Quality Audit Report

Hartfield Place, Swords Road, Whitehall, Dublin 9

Client:	AECOM
Document No:	220092-ORS-XX-XX-RP-7d-001

Revision	Status	Author:	Reviewed by:	Approved By:	Issue Date
P01	S2	TC	AP/JDK	DMcC	25/03/2022

Problem No. 06: Signage & Road Markings

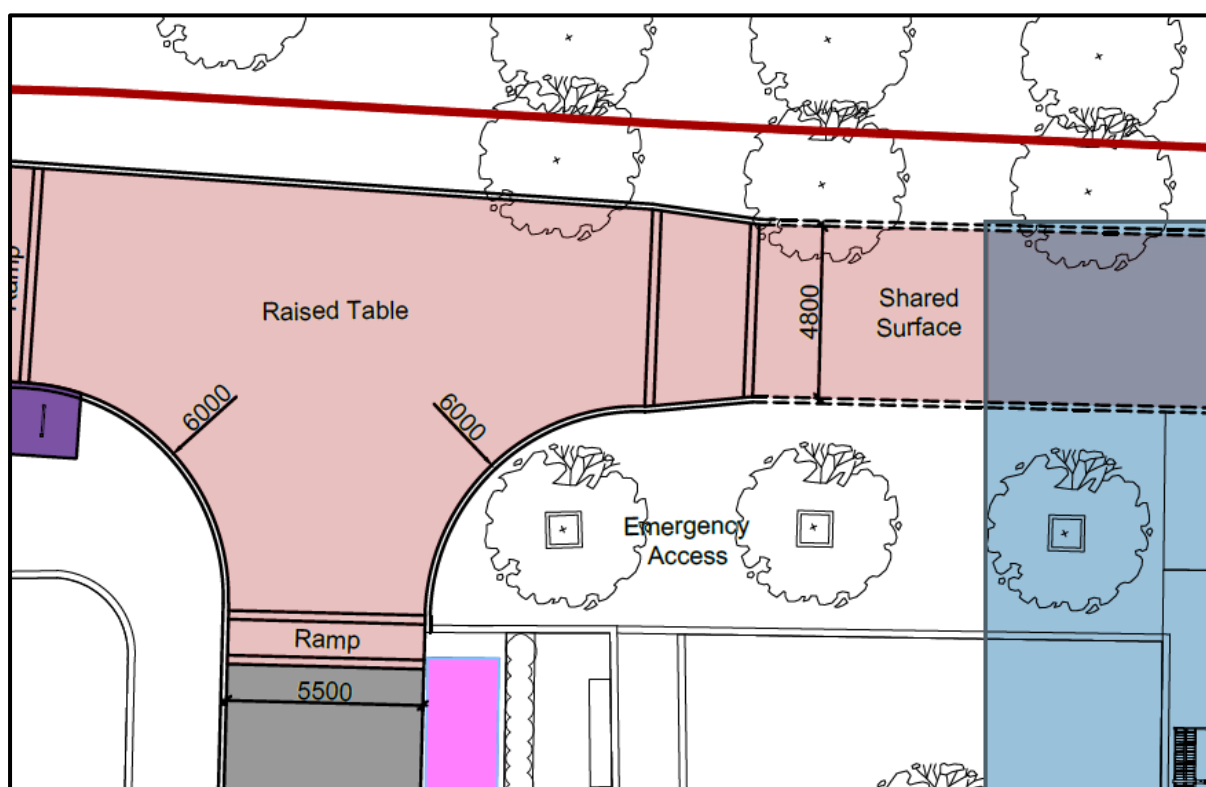
Location: Underground Car Park

The audit team note that there is a lack of signage and markings for the underground car park circulatory roads on the drawings provided. Signage and markings aid in informing road users of the direction of travel, exit routes and stop/yield locations. Inadequate signage and markings may lead to confusion for road users which may result in vehicle-vehicle conflicts causing injury.

The design team should include signage and road markings for the underground car park in line with Design Recommendations for multi-storey and underground car parks.

Problem No.08: Vehicle Swept Path Analysis

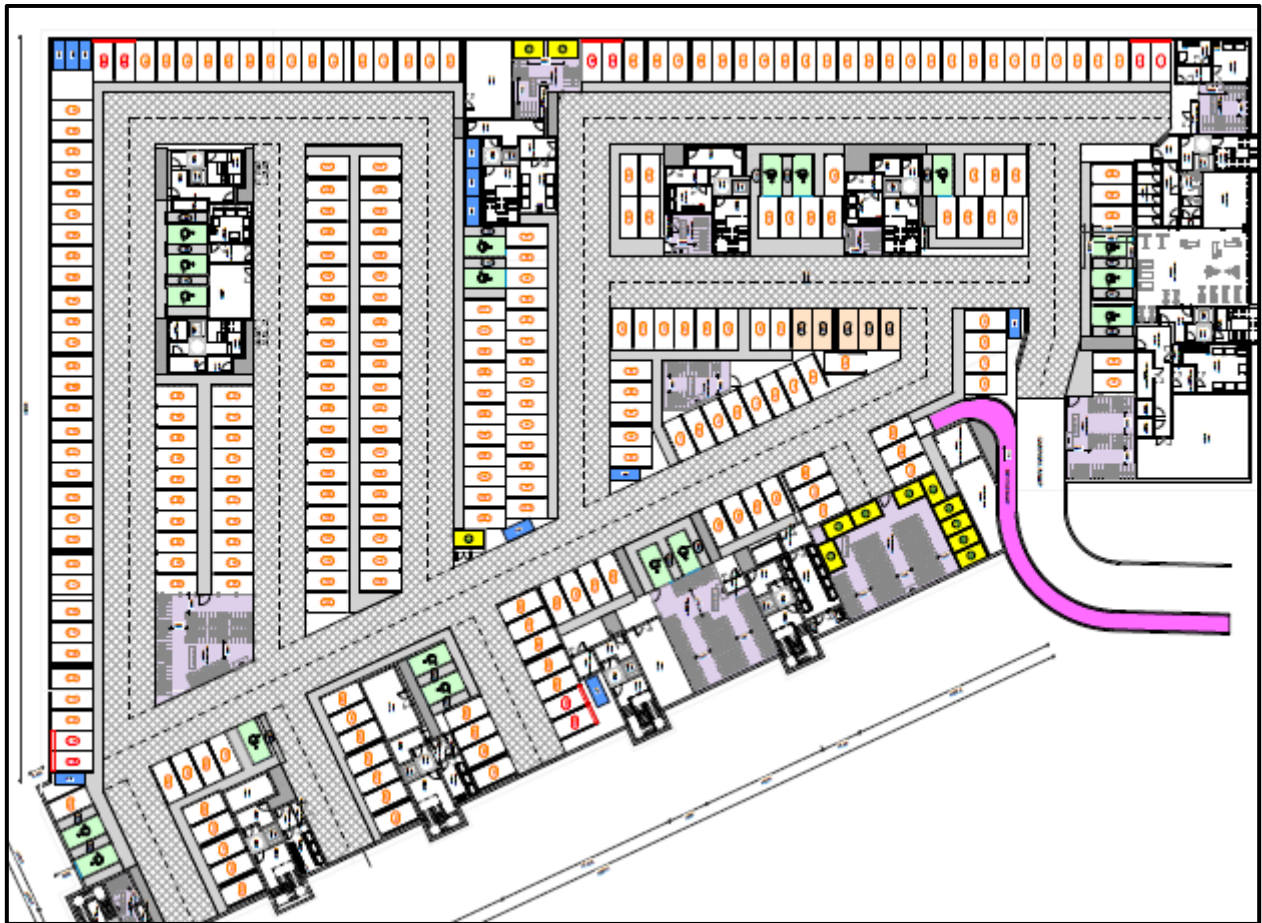
Location: Underground Carpark

The audit team note from the drawings provided that no vehicle swept path analysis has been completed for the underground carpark area. Swept path analysis should be conducted with the appropriate design vehicles to confirm the circulatory road layout is suitable for design vehicle turning movements. The swept path analysis should confirm that vehicles are able to navigate the carpark with continuous forward movements. The analysis should also analyse all applicable vehicle maneuvers and turning movements to ensure sufficient dimensions for carriageways and passenger vehicle parking bays.

The design team should analyse vehicle swept paths with industry standard software to assess vehicle wheel paths during turning movements to confirm the suitability of the road layout for intended vehicle purposes.
